PLANNING COMMISSION MEETING Monday, February 5, 2024

1. Design and site development review for a proposed 16-room motel building and site improvements at 3224 Pacific Avenue (Holiday Motel); Washington County Tax Lots 1S305BB00300, 00301 & 00302; File No. 311-23-000031-PLNG

Staff Report and Recommendation

REPORT DATE: January 29, 2024

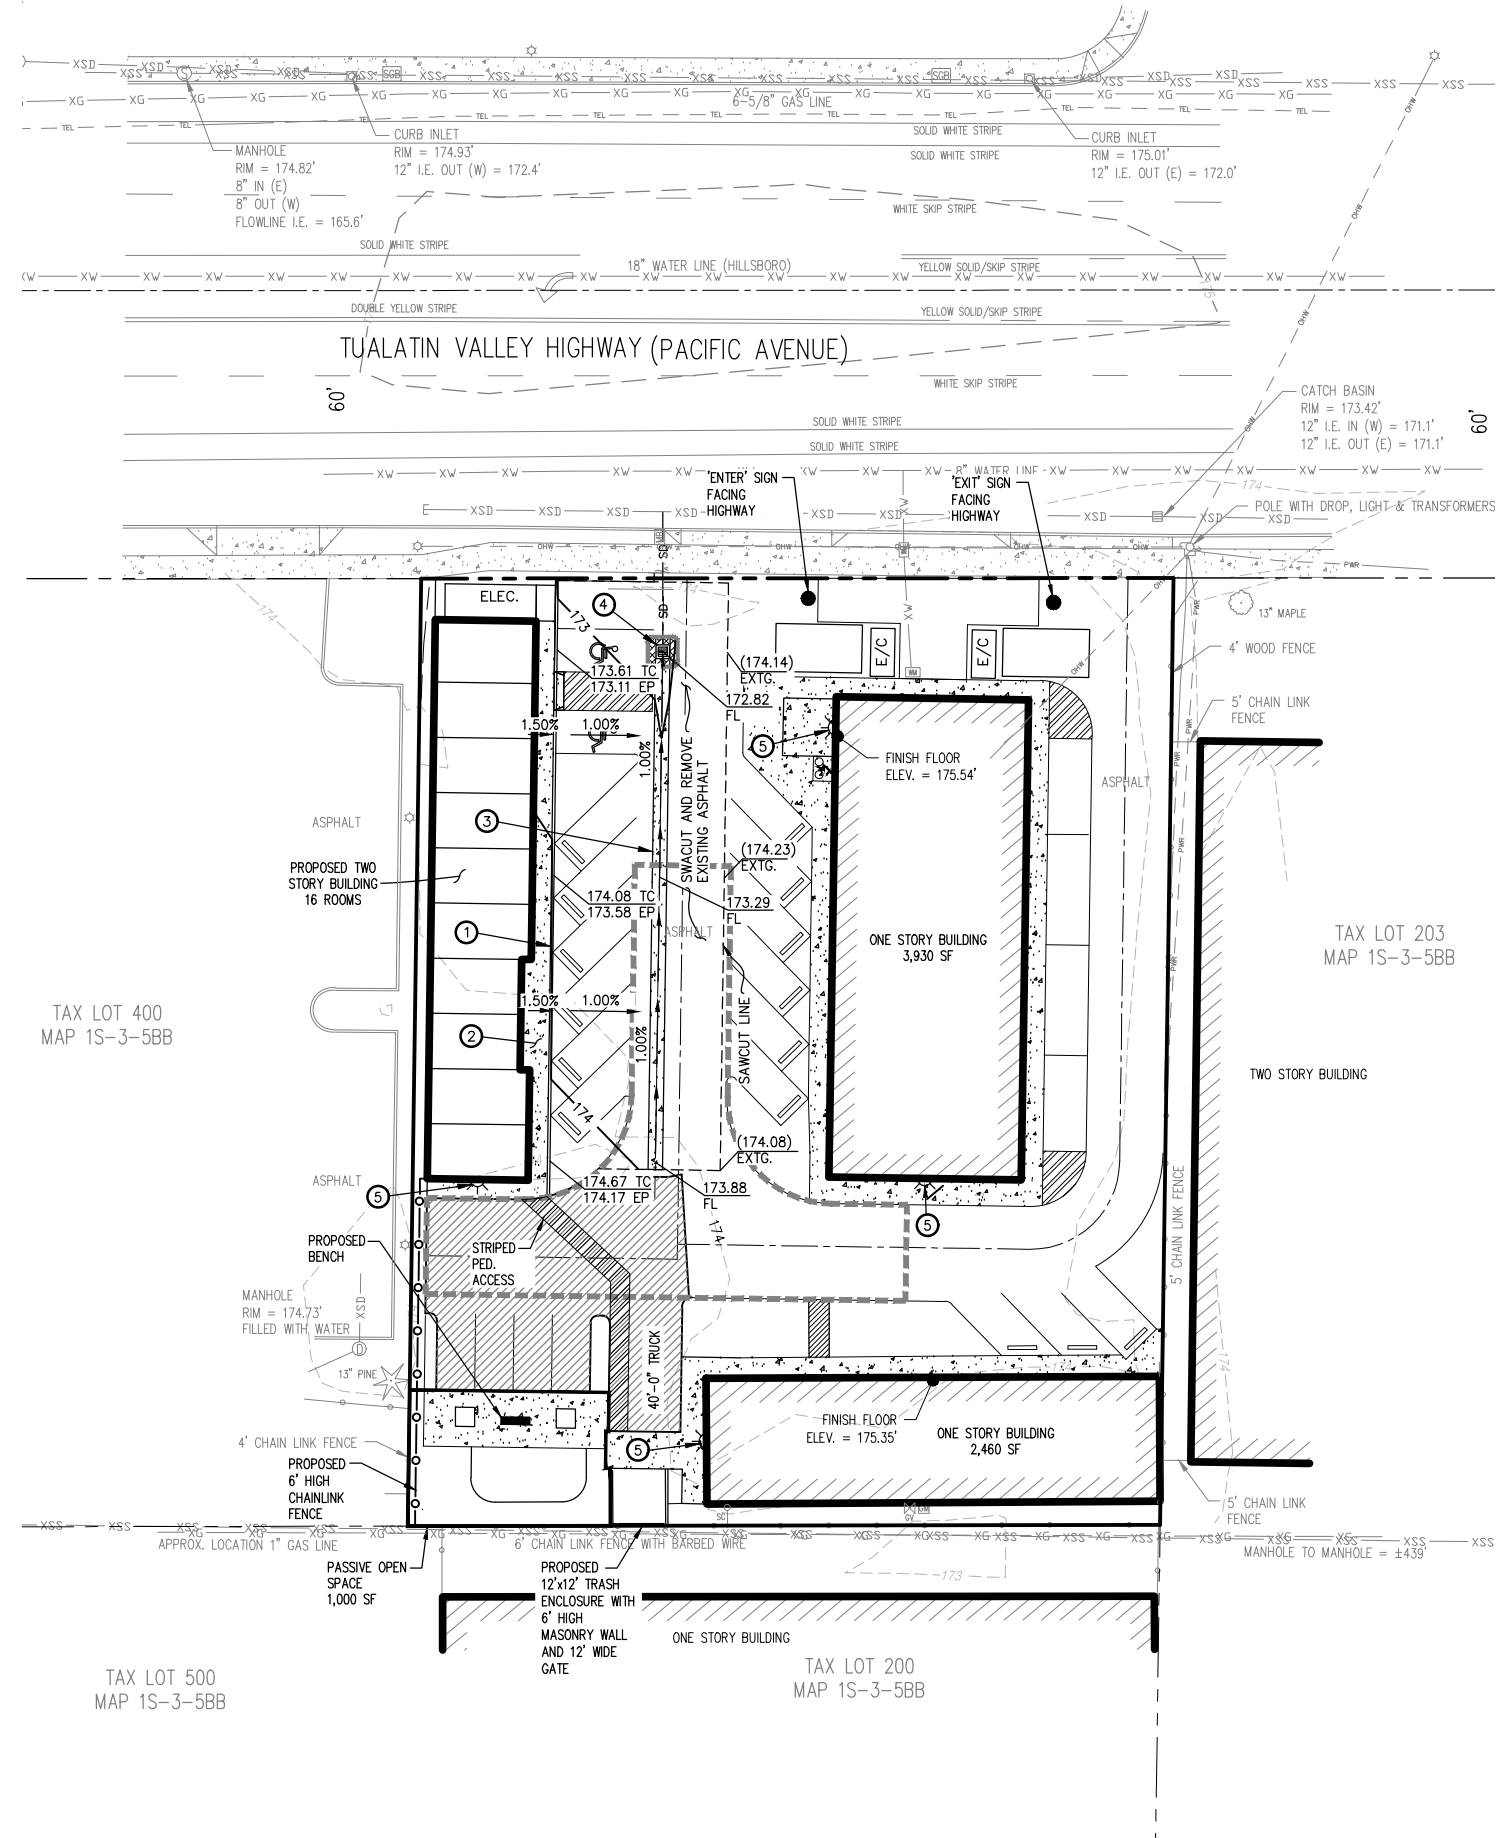
Finding: As shown on Plan Sheet 4, dated December 28, 2023, the proposed new motel building will add 4,906 square feet of building area to the site. Since Development Code §17.3.330(B), Table 3-9, indicates there are no maximum use size limitations in the Community Commercial the proposed motel expansion complies with this Development Code section.

Finding: Development Code §17.8.115(A)(3) states: Required walkways shall be paved with hard-surfaced materials such as concrete, asphalt, stone, brick, etc. Plan Sheet 4, dated December 28, 2024, indicates all walkways will constructed of hard surfaced material/concrete. Therefore, this standard is met.

Finding: Plan Sheet 4, dated December 28, 2023 and provided by the applicant, shows the location of the trash collection area near the south property line away from the public right-of-way. The proposed trash collection area is located near the common property line adjacent to the Northwest Self Storage site. A 40-foot by 15-foot loading area is provided trash collection vehicle parking. This allows for trash collection vehicle parking outside of the drive aisle which minimizes conflicts with auto and pedestrian circulation.

8. As required by Development Code §17.8.115 (A)(3), and shown on Plan Sheet 4, pedestrian walkways shall be constructed of hard surface material/concrete.

13. Prior to building permit application, submit a geo-technical report for review by the City's Building Official.
14. A refuse collection area shall be provided as shown on Plan Sheet 4, dated December 28, 2023. Screen the refuse collection area by placement of a solid wood fence, masonry wall or evergreen hedge at least six feet in height. Gate openings which allow access to users and haulers shall be provided. Gate openings shall be a minimum 10 feet wide and capable of being secured in a closed and open position. (Development Code §17.7.205(C)(3).

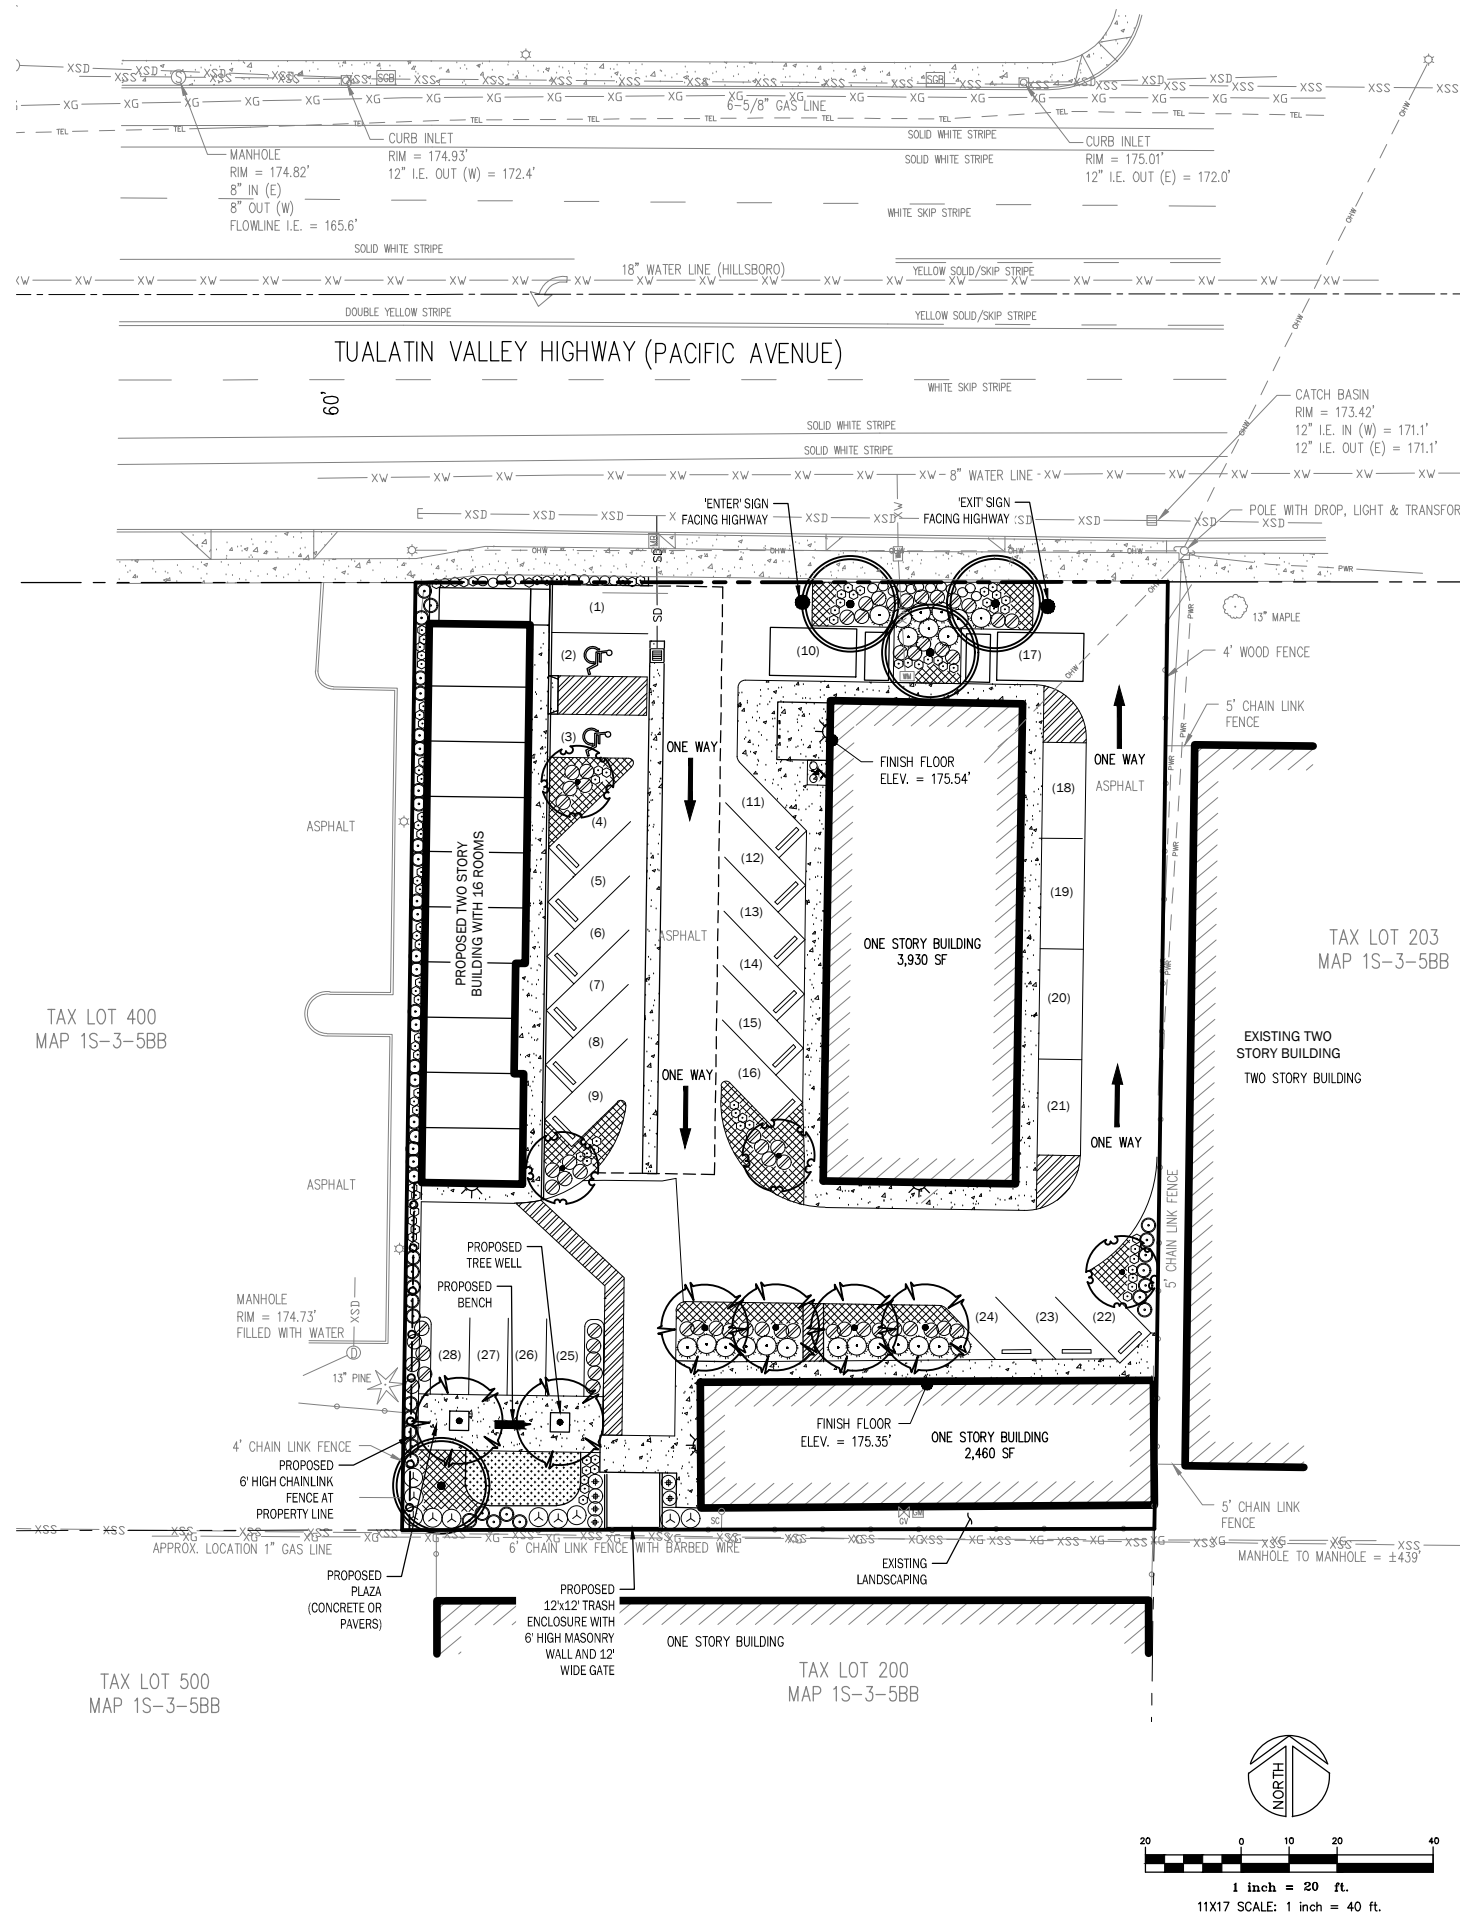
Finding: The Development Code requires that at least 15% of the site area be landscaped (Development Code §17.3.330(B), Table 3-9). The applicant submitted a preliminary landscape plan showing planting locations and types (Plan Sheet 7). The applicant's narrative statement, on page 21, indicates that the proposed landscape area is 5,270 square feet, or 17% of the site area, and exceeds the minimum 15% required. The ensure compliance with the landscaping requirement a condition of approval is proposed to require at least 5,270 square feet of landscaped area in the locations shown on Plan Sheet 7 dated December 28, 2023).

Finding: Development Code §17.8.405(C) states: “The applicant shall submit a landscape plan.” The applicant provided a landscape for review. The landscape plan is labeled Plan Sheet 7, dated December 28, 2023. This standard is met.

Finding: The landscape plan, dated December 28, 2023, shows 14 trees that will be planted throughout the site. Three trees area proposed between one of the existing motel buildings and the public right-of-way.

7. The development shall provide at least 5,270 square feet of landscaped area in the locations shown on Plan Sheet 7 dated December 28, 2023). The applicant shall submit final landscaping plans with the civil plan set for City review and approval. Approved landscaping shall be installed prior to building permit final approval.

9. The parking space labeled as parking space 1 on Plan Sheet 7, dated December 28, 2023 shall be eliminated and this area shall be landscaped with groundcover and the applicant shall install one street tree approved by the Planning Division prior to final building approval and issuance of a certificate of occupancy.

WEST ELEVATION

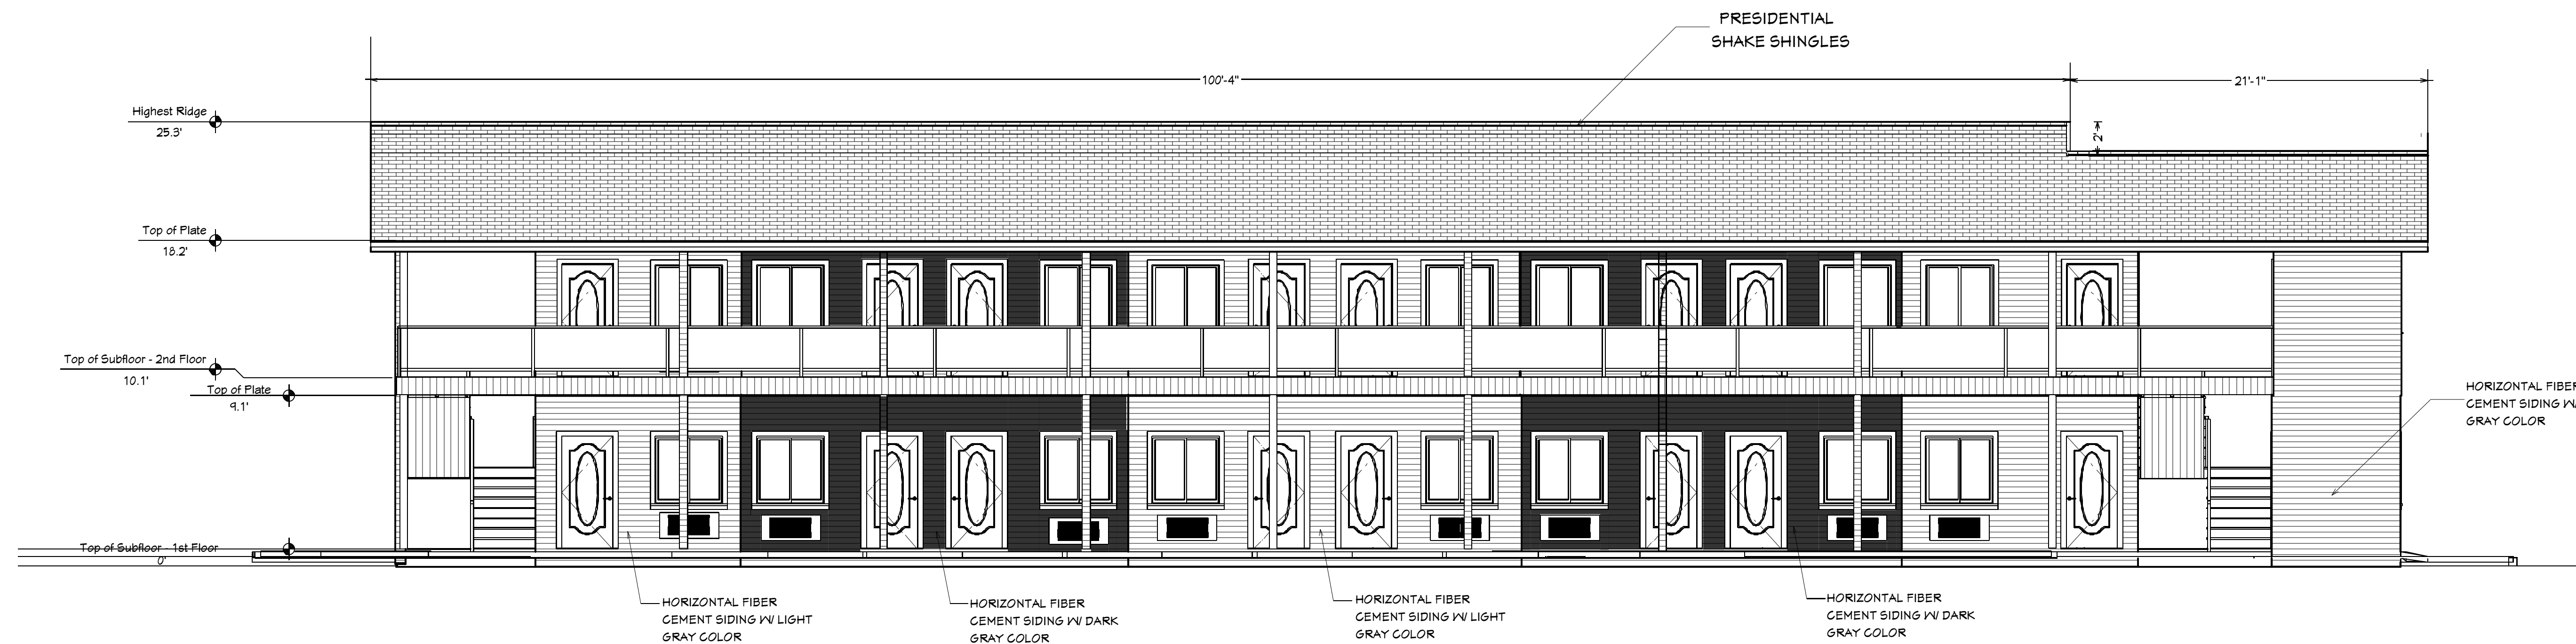
The elevation facing the property line separating the Holiday Motel site and Jack-in the box property to the west is shown below. The applicant proposes using color change (dark and light gray) to soften the bulk of the blank wall.

Finding: The building elevations provided by the applicant do not show dividing large masses by varying façade heights—and rooflines. The applicant proposes the use of color differentiation to minimize the appearance of bulk.

5. The building elevation facing the west property line shall include horizontal and vertical elements to provide visual variety in addition to color changes.
